**Product Change Notice:** #VE20200418

**RE: Product Branding Change**

**Old Image Example**

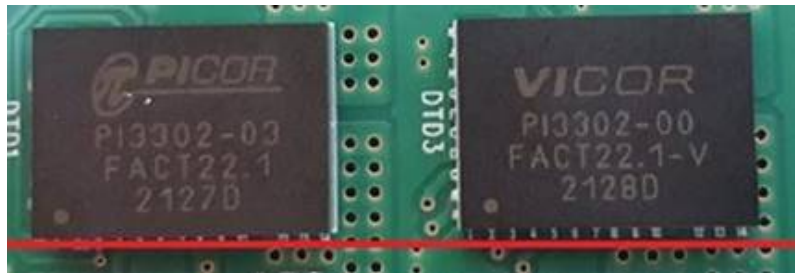
Specific products have a new brand marking.  
Product marking changes from the Picor mark to the Vicor mark.  
No other changes are made to these products.
